Defect free strain relaxation of microcrystals on mesoporous patterned silicon

REVIEWER COMMENTS

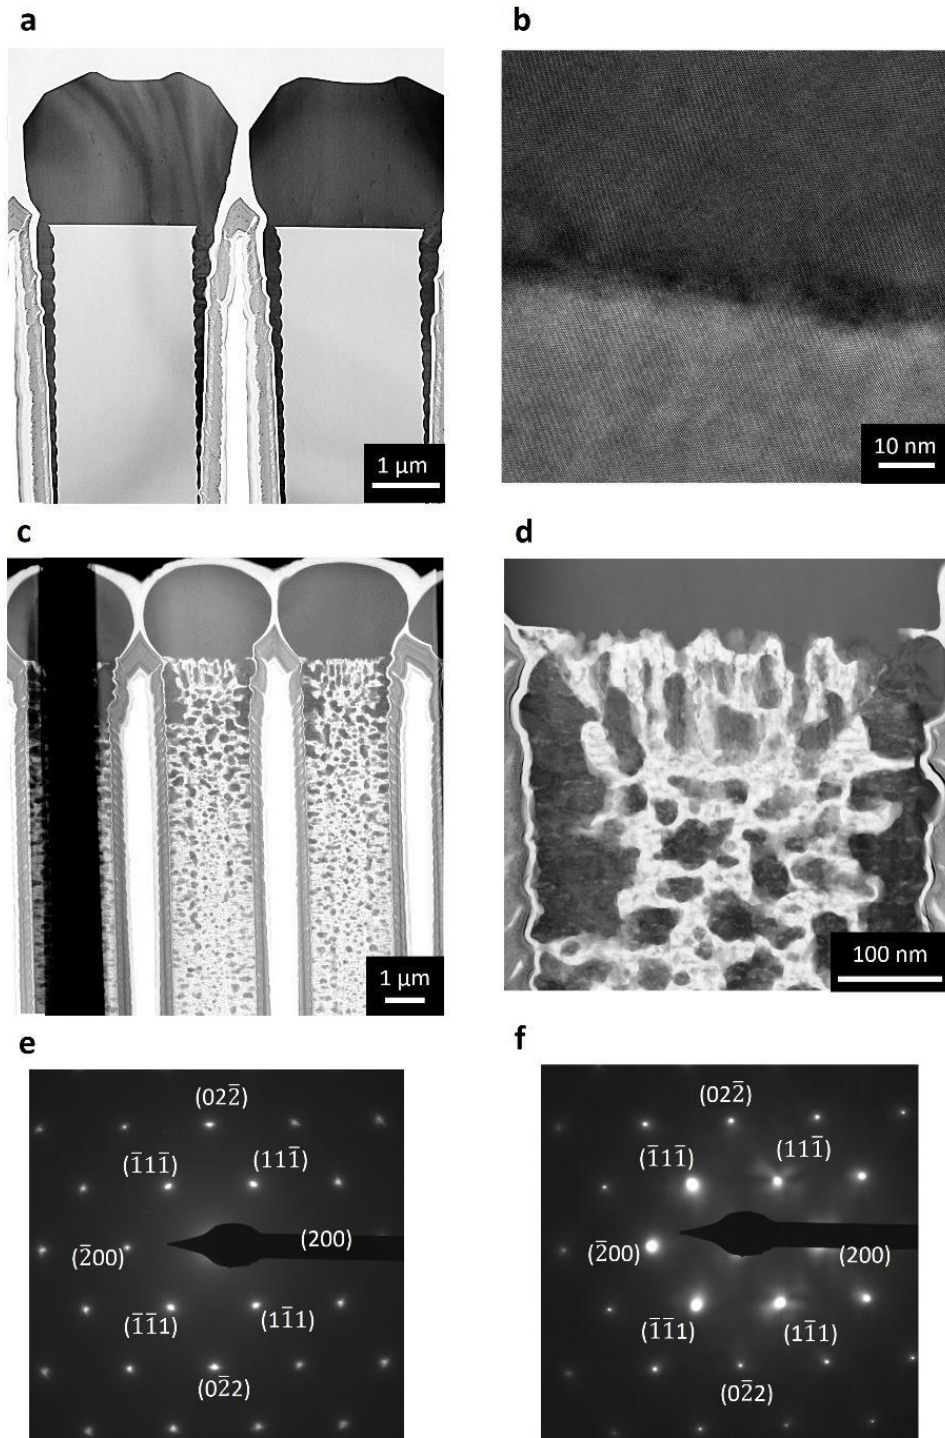
R2.1-a Clear description of porosification of Si pillars: According to Figs. 1 (b) and (d), the porous region is limited in the bottom regions of the pillars though the wet etching procedure would make porous regions in the whole pillars. I recommend the authors to clarify if the authors intentionally formed porous regions at the bottoms. The question brings additional questions. If the porous regions are confined at the bottoms, 'compliant' substrate behavior would be affected by the volume of the porous region. For instance, the Si pillars can be 'compliant' substrate when the volume of the porous region is higher than certain value. The authors need to discuss the effect.

R3.2 In figure1 the porous silicon seems to be present only at the bottom of the micropillar. The description of the Si structure in between the Ge microcrystal and the bottom porous part is lacking. The Ge stands on this structure.

We understand that the SEM image in the figure 1, showing only the bottom part of the porosified pillar, can be confusing. Indeed, the upper part of the pillars cannot be observed due to a screening effect coming from the Ge deposition on the lateral surface of the pillars. Meanwhile, the Si pillars have been entirely porosified as can be observed on TEM images (Supplementary Material: Fig. S5(c) and S5(d)) testifying that the porous region extends all over the pillar's height.

We thank the reviewer for this comment. Indeed, the Si pillars have been entirely porosified as can be observed on cross section TEM images (Fig. S5(c), S6(a) and S7(a)). However, after Ge growth, the upper part of the porous Si pillars cannot be observed by SEM due to the screening effect coming from the Ge deposition on the lateral surface. For this reason, the description of the Si structure in between the Ge microcrystal and the bottom porous has been made later in the manuscript (starting from the last paragraph of the page 6) based on cross section TEM, XRD and EDX analysis (Supplementary Fig. S6 and S7). Accordingly, during the epitaxial growth, Ge atoms are found to diffuse into the PSiP forming SiGe alloy with graded composition. The alloying effect is mediated by the porous Si reorganization and Si/Ge intermixing. Further explanation of the reorganized pillars alloy materials' properties has now been included in the corresponding section.

Fig. S4. Etch-Pit method of Ge microcrystal on various substrate. TOP view SEM images of Ge/SiP(a), Ge/PSiP(50%)(b), Ge/PSiP(70%)(c), after Etch-Pit method.

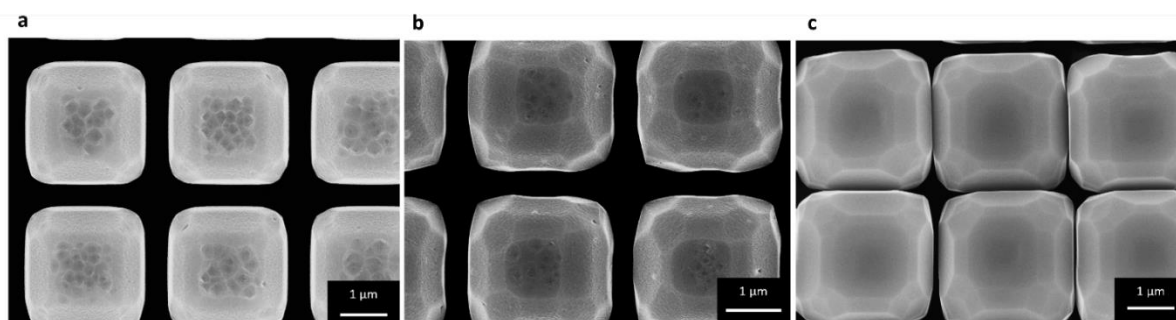
R2.2 Nucleation behavior of Ge microcrystals: According to Figs 2 (c) and (d), facet formation of the Ge crystals is different along the substrate preparation procedure. The facet formation shown in Fig. 2(c) is commonly observed. However more spherical shape shown in Figure 2(d) is not common for Ge on Si. The authors can bring fruitful discussion on the facet formation governed by nucleation on different substrates.

Indeed, the facet formation exists in all the investigated structures regardless the substrate preparation procedure as shown by the Top view SEM images (Supplementary Fig 4). In the meanwhile, the pillars porosification is found to induce faceting morphological changes. The difference in morphology can be attributed to the lack of a unique/dominant plan due to the porous template. The porous silicon pillars exhibit crystallites, each of them constitutes a nucleation site for Ge crystal resulting in a reduced area of $\langle 001 \rangle$ facet in favour of increasing that in the other crystallographic orientations.

We have added our answer in the manuscript (page 6, paragraph 1), as well as this new figure in the supplementary information:

Fig. S4. Etch-Pit method of Ge microcrystal on various substrate. TOP view SEM images of Ge/SiP(a), Ge/PSiP(50%)(b), Ge/PSiP(70%)(c), after Etch-Pit method.

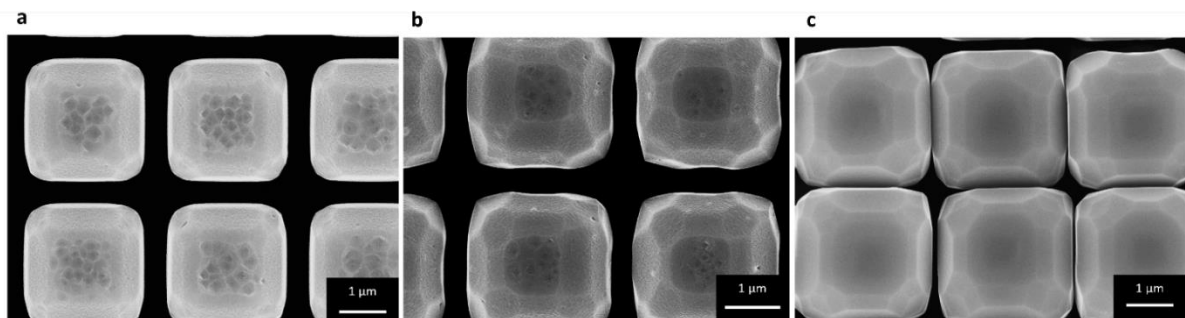
R3.3.a Finally, the authors should describe the impact of porosity on the Ge structure and dislocation density.

Indeed, following the recommendation, we have performed new etch-pit counting on Ge/PSiP(50%). The results show a reduced TDD suggesting an improved crystalline property of the Ge microcrystals for intermediate porosity but still below the threshold porosity allowing full strain accommodation. As we can observe, the defect density decreases with increasing the pillars porosity which attest the capacity of this compliant substrate to accommodate the strain.

- We have added this new figure in the supplementary information:

To assess the impact of intermediate porosity on the TDD, Etch-pit counting on Ge microcrystals grown on 50% PSiP (Supplementary Fig. 4) revealed that the TDD decreases down to $2.5 \cdot 10^8 \text{ cm}^{-2}$. The decrease of the threading dislocation density confirms that the crystalline quality of the Ge microcrystal's gets progressively improved with increasing the PSiP porosity."
